**RECALL
BULLETIN:**
170914REV

Fleetwood Bounder
manufactured
March 24, 2014
through May 22,
2015 (DC Level
510 thru 609)

Fleetwood
Southwind
manufactured
March 11, 2014
through March 2,
2016 (DC Level
500 thru 625)

SUBJECT:
Inspection /
Correction of
Battery Tray
Installation

Figure 1

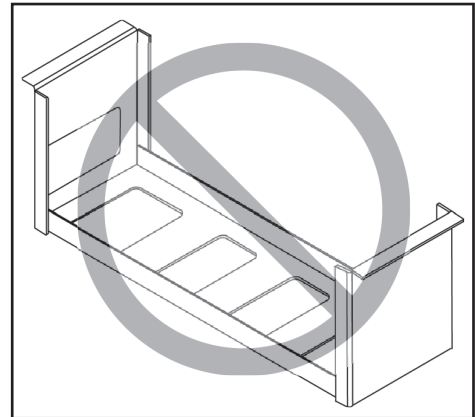
- a) If the battery tray is formed as one solid piece (has no angle steel members) as shown in **Figure 1**, no repairs are necessary. Take photos and then reinstall the entry step cover. Ensure the bulb seal is properly positioned around the perimeter before reinstalling the cover.

If the battery tray is formed as one solid piece as shown above, no repairs are required.

Figure 2

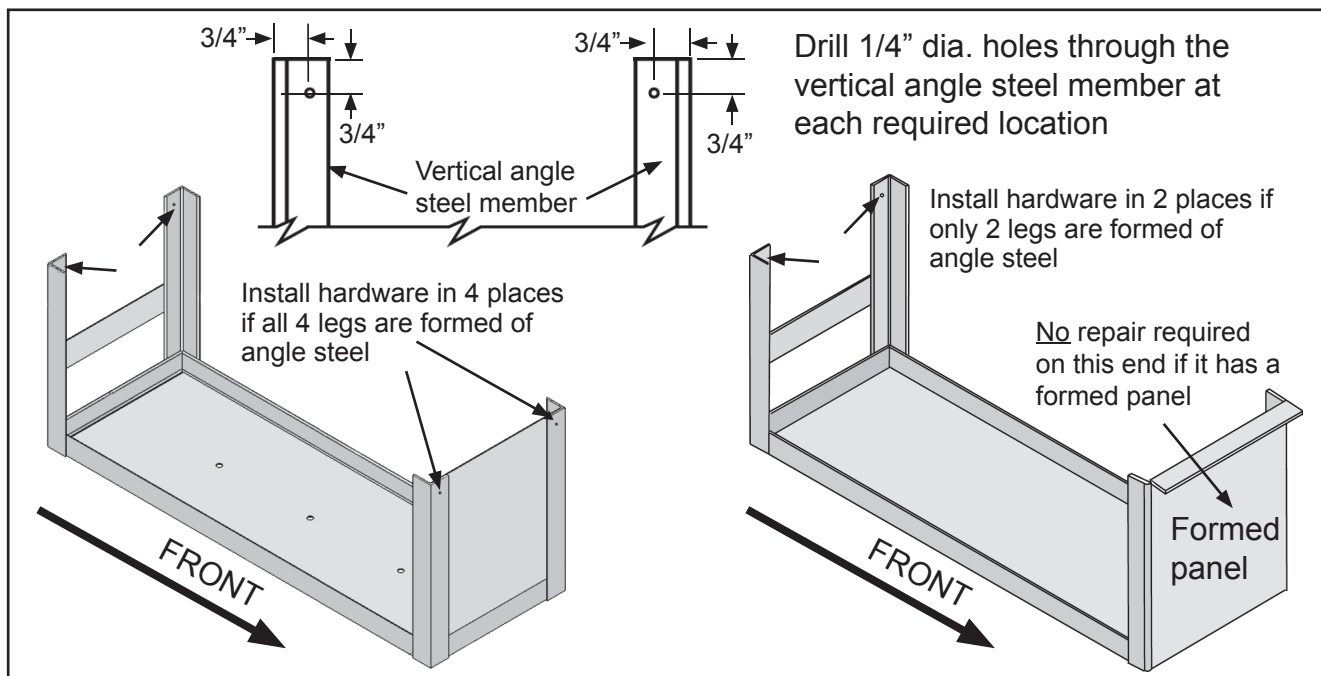
- b) If the battery tray has 2 or 4 vertical members composed of angle steel as shown in **Figure 2**, continue to CORRECTION, Step 5, next page.

If the step cage is constructed with either (2) or four (4) angle steel members, repairs are required.

5. Locate the upper corners of the battery tray's vertical angle steel members. Using **Figure 2** on Page 2 as a guide, drill a 1/4" diameter hole through the vertical angle steel and the chassis structural steel, in each required location.
6. Install a grade 5 bolt, two flat washers, and a nylon lock nut at each newly drilled location, using the stacking order shown in **Figure 3**. Tighten nuts to 12 -15 ft./lbs. See Parts list for hardware requirements.
